Town of Hilton Head Island
Board of Zoning Appeals Meeting
Monday, April 26, 2021 – 2:30 p.m.
AGENDA

**STAFF REPORT
VARIANCE**

Case #: VAR-002385-2020	Public Hearing Date: April 26, 2021
-----------------------------------	---

Request from Dennis Antoccia for a variance from 16-5-102, Setback Standards and 16-5-103, Buffer Standards to allow a shed, paver pathway, and paver patio to remain in the adjacent use setback and buffer. The property address is 12 Circlewood Drive with a parcel number of R510 005 000 0341.

Attachment C - Subdivision Plat

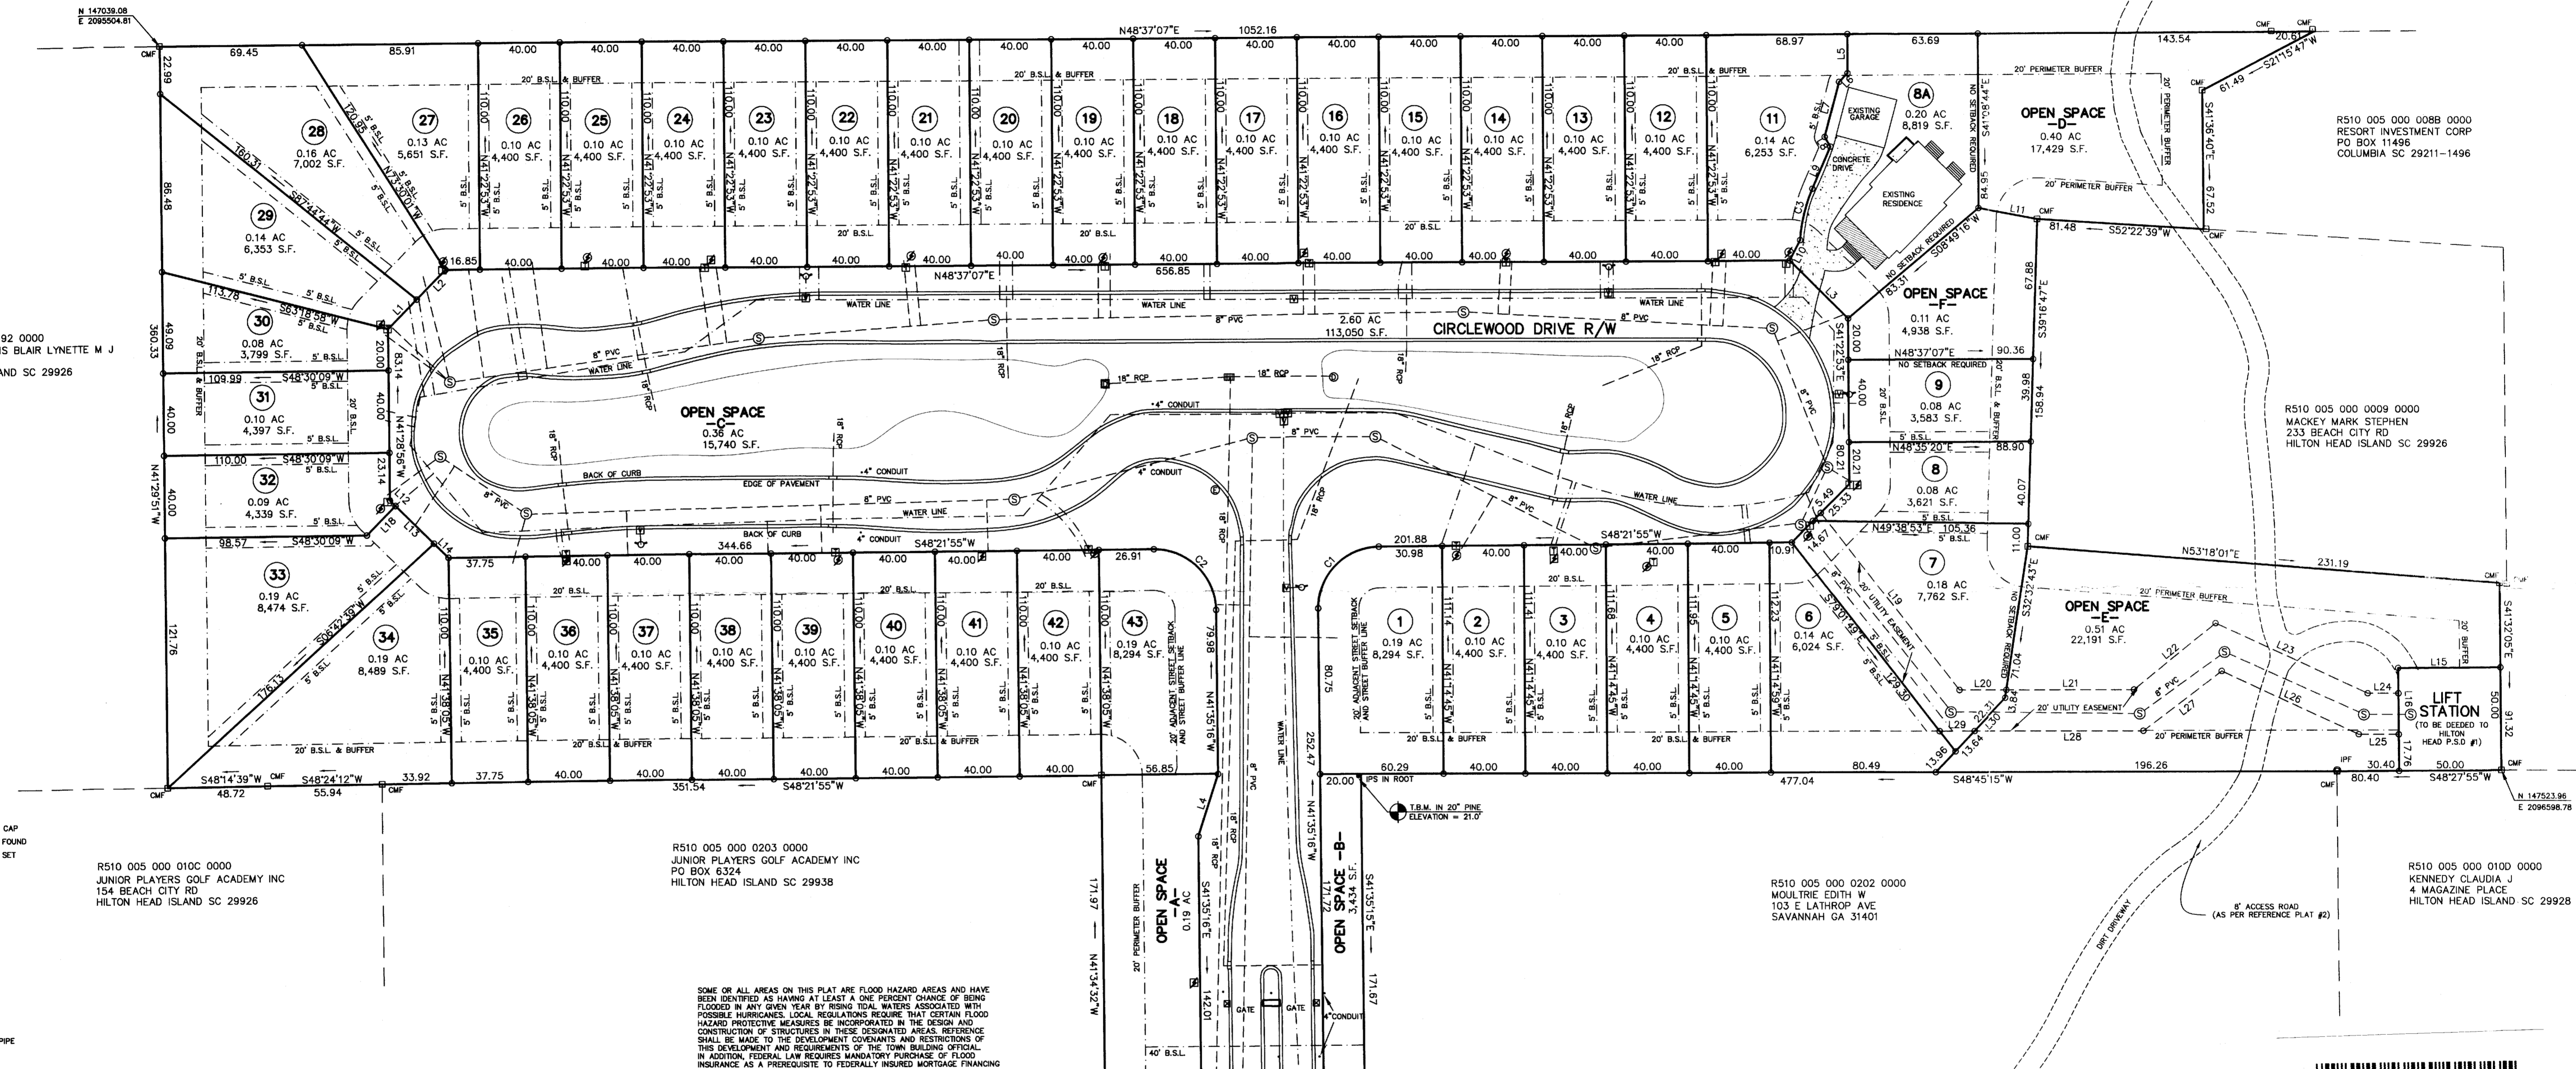
The Beach City Place subdivision was approved with a 20 foot adjacent use setback and buffer around the perimeter of the entire subdivision (with the exception of Lot 7 which is adjacent in the rear to Beach City Place open space), as shown on the subdivision plat (See Attachment C, Subdivision Plat).

- The approved subdivision plat for the Beach City Place subdivision has a note that reads, "the only activities permitted in the exterior subdivision buffer as labelled on this plan shall be those listed in permitted activity in other buffer areas as per the LMO".

Attachment E - Approved Site Plan for Addition

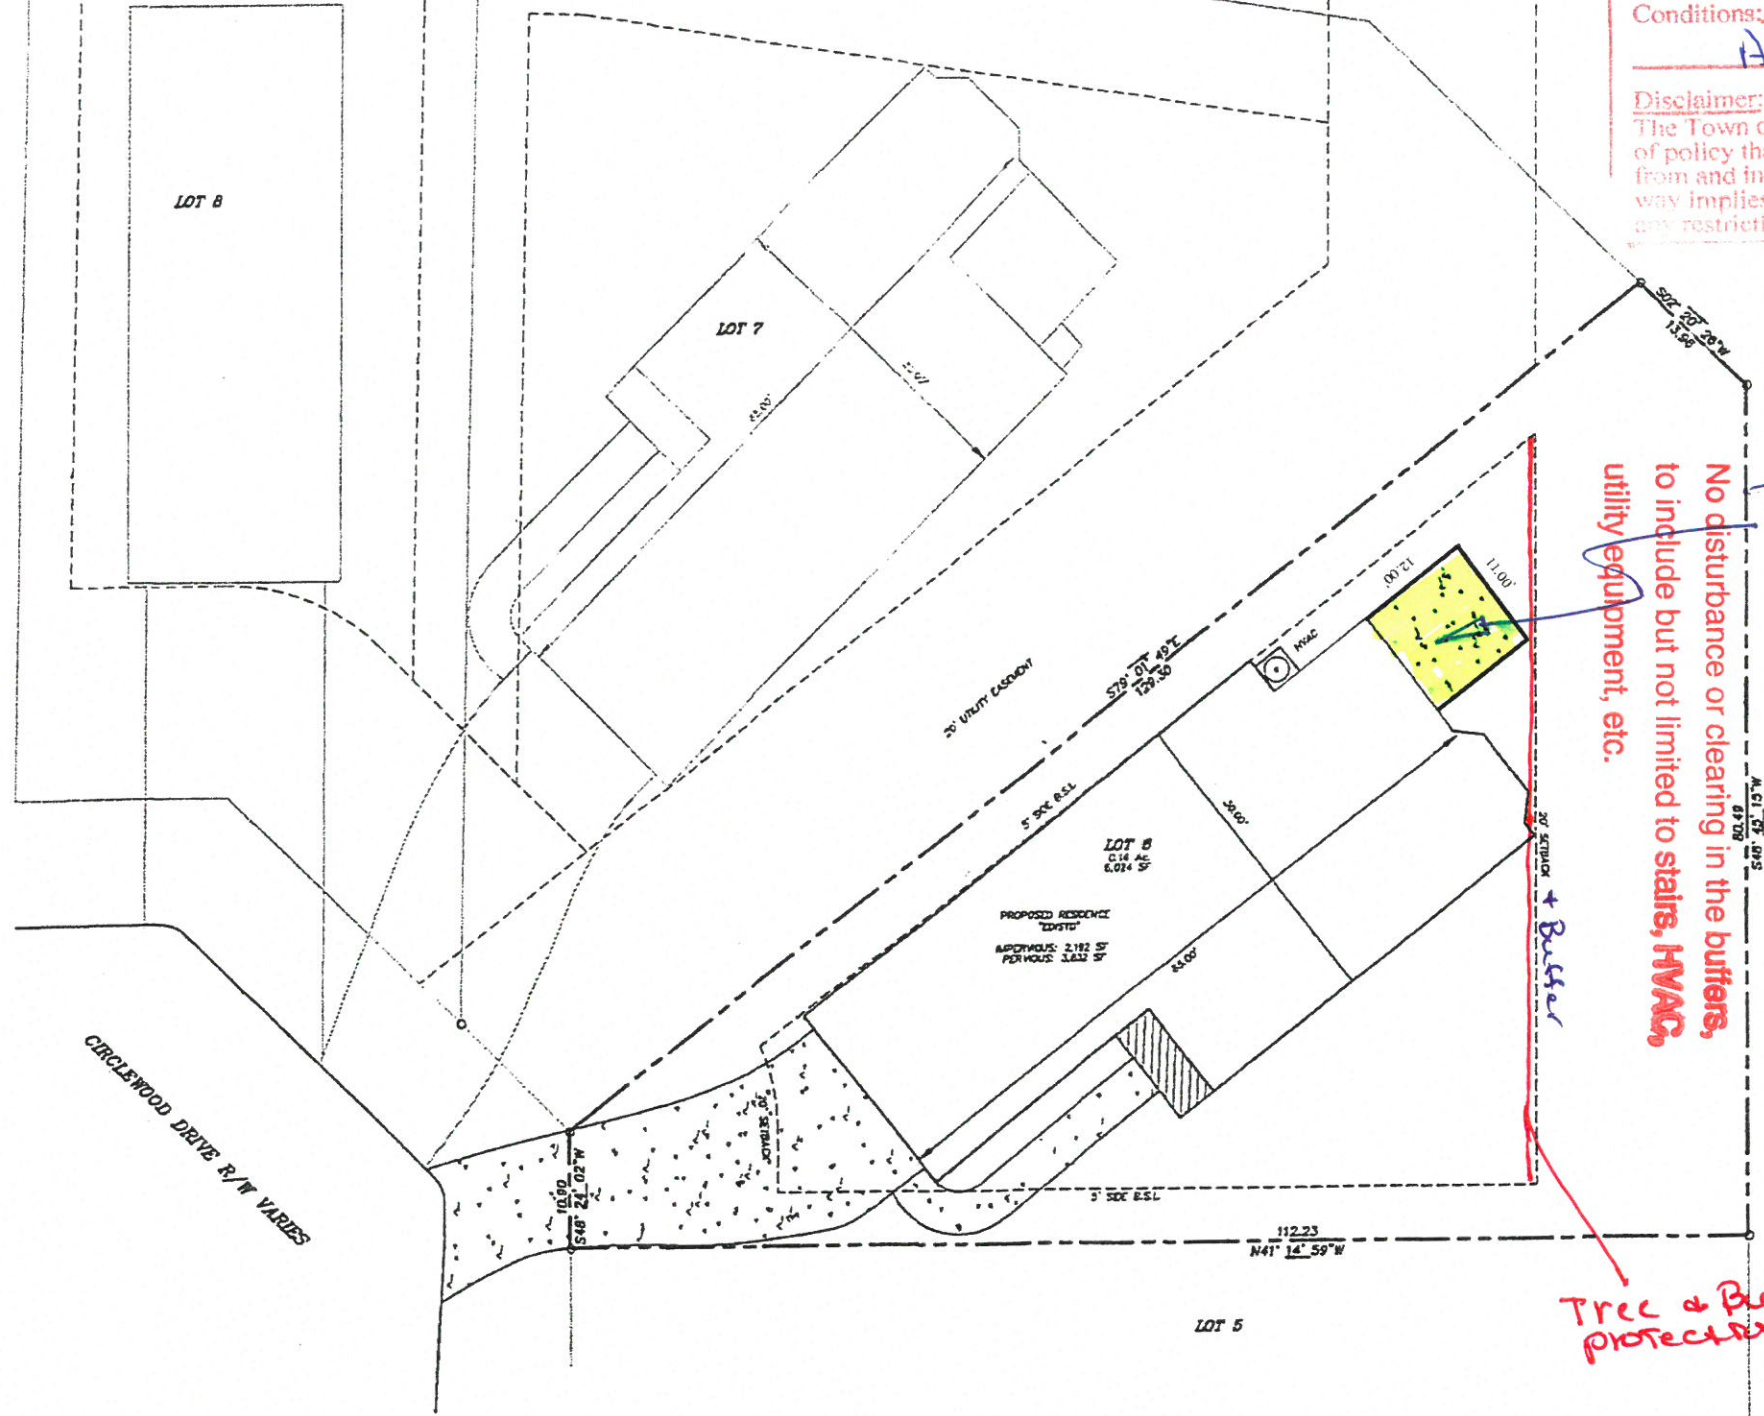
issued as well as stamped Town approved plans. The plans that were associated with the screen room addition had a bold red note that delineated the rear adjacent use setback and buffer and read, “No disturbance or clearing in the buffers, to include but not limited to stairs, HVAC, utility equipment, etc.” (See Attachment D, Approved Site Plan for Addition).

- An 11' x 32' screened room addition has been constructed at the subject property.
- The approved plan that corresponds with the construction of the existing 11' x 32' screened room addition has a note that delineates the setback and buffer area and reads, "No disturbance or clearing in the buffers, to include but not limited to stairs, HVAC, utility equipment, etc."

No disturbance or clearing in the buffers, to include but not limited to stairs, HVAC, utility equipment, etc.
